City of Portland, Maine - Building or Use Permit Application

Location of Construction: 281 VERANDA ST	Owner Name: ATLANTIC PROPERTIES LLC	Owner Address: 970 BAXTER BLVD	Phone:
Business Name:	Contractor Name: Donatello Builders Inc./Larry	Contractor Address: P.O. Box 684 Portland	Phone: 2072327220
Lessee/Buyer's Name	Phone:	Permit Type: Additions - Commercial	Zone: R-P

Past Use: Commercial - Office - <i>doctors</i>	Proposed Use: Commercial - Office - 62 Sq Ft addition & interior renovations to existing space <i>real estate "Remax"</i>	Permit Fee: \$490.00	Cost of Work: \$47,000.00	CEO District: 4
		FIRE DEPT: <input checked="" type="checkbox"/> Approved <input type="checkbox"/> Denied	INSPECTION: Use Group: <i>B</i> Type: <i>SB</i>

**Subject:** Structural design and review of structural modifications to your building located at 281 Veranda St., in Portland, Maine

Determination of 75' setback from High Water Line 281 Veranda Street <span style="float: right;">Portland, Maine</span>		
MADE FOR <b>David Banks</b>		
JOB# 201041	DATE: Dec. 7, 2007	SCALE: 1"=20'
BOOK# 715-38	 <i>Titcomb Associates</i> 133 Gray Road Falmouth, Maine 04105	
DISC#		
FILE#

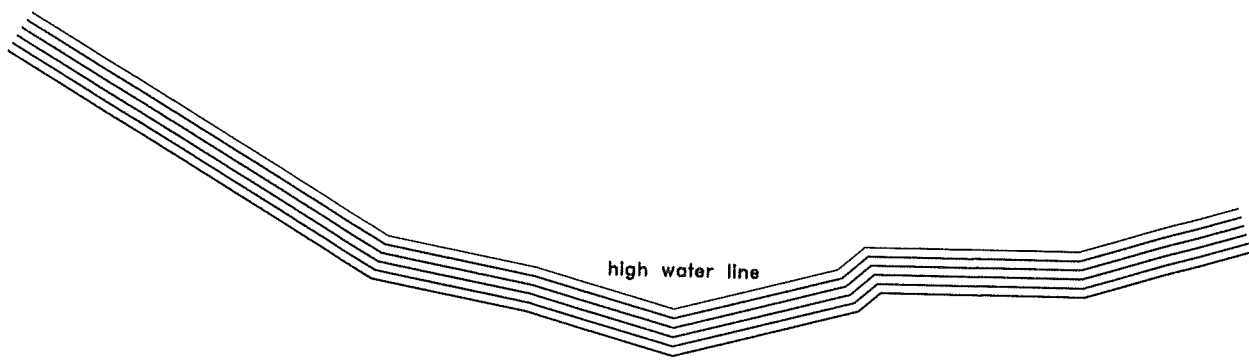
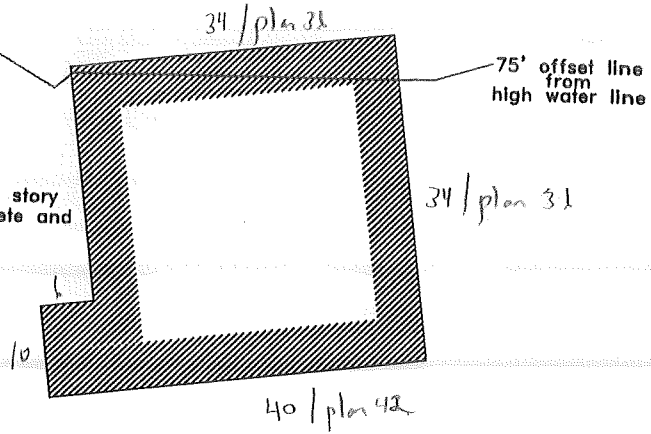
11/27/2007-amachado: Spoke to Michael Banks. David Banks is the owner. The addition is on the plan. It is not a change of use because it is still a professional office (real estate). I told him that we need a survey that shows where the 75' setback is from the highest spring tide because the property is within the shoreland zone.

12/14/2007-amachado: Met with David Banks. Received siteplan yesterday done by Titcombs indicating the 75' setback line from the high water. Need original, stamped and scalable plan. Need information to figure out the volume of the existing building and the proposed addition.
